Port of London Authority
Chart Correction Advice
Date: 29th Nov 2013

CCA No: 2013/79

Chart: Sea Reach

PLA Chart No. 340
HO Ref No. 113-340-184
Previous Chart Correction: 2013/79

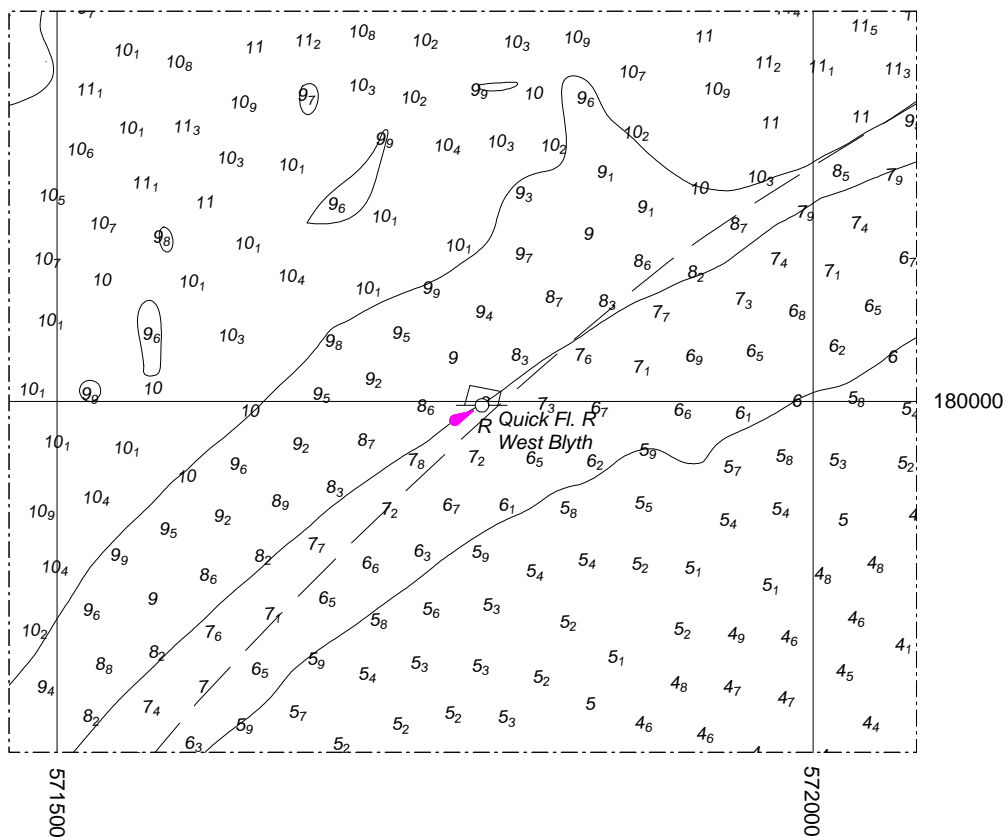
The accompanying block correction shows that West Blyth Bouy has been moved approximately 600 metres South West of its current charted position, to 571781 E / 179997.34 N. NB. Light characteristics have also changed.
